Lahontan Regional Water Quality Control Board

**PROPOSED AMENDMENT TO THE WATER QUALITY CONTROL PLAN
FOR THE LAHONTAN REGION**

**Removal of the Municipal and Domestic Supply (MUN) Beneficial Use Designation
from Ground Waters of Naval Air Weapons Station China Lake, Kern, Inyo, and
San Bernardino Counties**

Figure 2-2

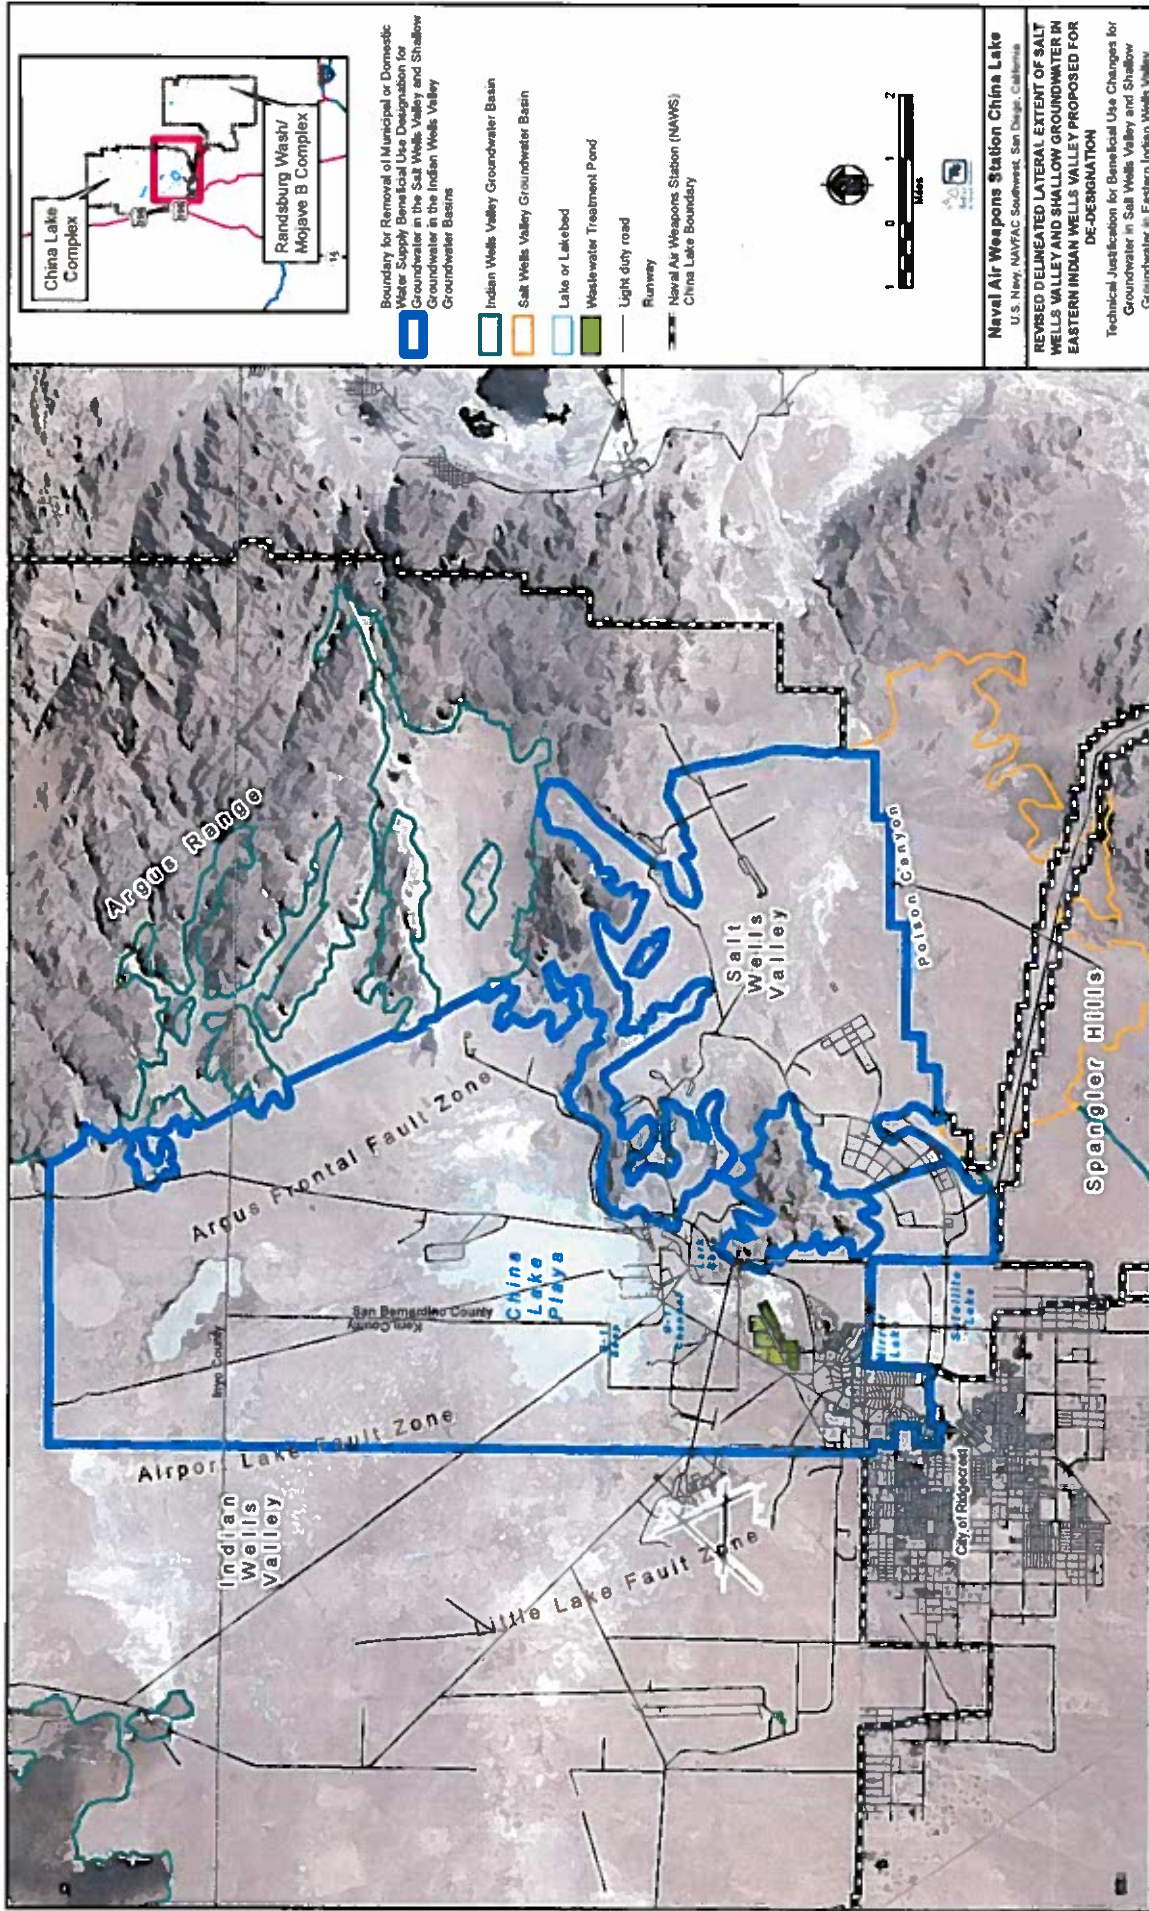
“Note #2: The MUN designation does not apply to the ground waters located beneath the Salt Wells Valley and those within the shallow groundwater (above the top of the low-permeability lacustrine clay sediments) in the eastern Indian Wells Valley groundwater basins as shown on Figure 2-2.”

Add Figure 2-2 (attached).
